# **Official Transcript of Proceedings**

## **NUCLEAR REGULATORY COMMISSION**

Title: Advisory Committee on Reactor Safeguards  
AP1000 Subcommittee [Open Session]

1 review a Westinghouse Topical Report, WCAP 17938-P  
2 Revision 2 entitled AP1000 In-Containment Cables and  
3 Non-Metallic Insulation Debris Integrated Assessment  
4 and the associated staff Safety Evaluation Report.

## WCAP 17938 Purpose

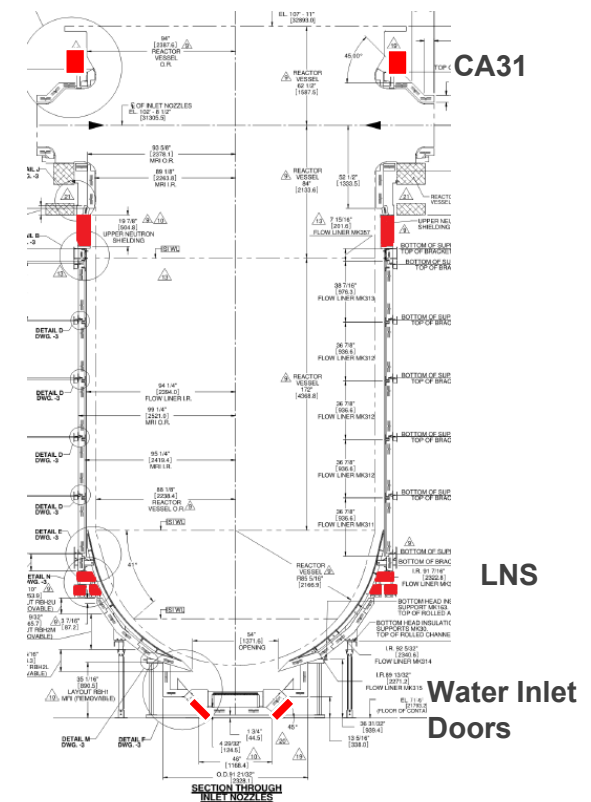
2 MEMBER REMPE: So, when I was reviewing  
3 the information for this meeting, I kept thinking to  
4 myself, jeepers, shouldn't Westinghouse have known that  
5 the cabling -- I mean, this isn't your first PWR, right,  
6 that would exist and these materials might exist and  
7 that you might need this material?

8 And, why, you know, right now, the way you  
9 presented it, it was like, well, okay, we figured you  
10 might have to do some qualification for NMI.

11 But, I just was surprised. I mean, did  
12 this all come as a surprise to you all and you didn't  
13 think about it during design certification?

14 MR. PFISTER: So, I'll take the question  
15 on cabling first because they're separate.

16 Traditionally, cabling isn't considered  
17 a source of debris for GSI 191. As we try to do, we  
18 look into what the industry has done. That's not a  
19 source that's generally being considered as a debris  
20 generation source.

1           And so, as we went through the process of,  
2           you know, defining the specification for cabling,  
3           working with vendors and procuring cabling, you know,  
4           we became aware that there is fibrous materials as  
5           insulation within some cables, not all cables. But,  
6           that is a material that cable vendors use.

10          And, because we work through NEI guidance  
11          where we have established ZOIs, whether it was through  
12          an NEI program or a PWR OG program or something specific  
13          for AP1000, there had never been an established ZOI  
14          for cabling.

15          So, we identified, this is a gap and said,  
16          not necessarily that it is a debris source, but it  
17          certainly could be one. So, we had to take the  
18          necessary steps to say, where must it be located  
19          relative to high energy lines in order to preclude it  
20          from being a debris source?
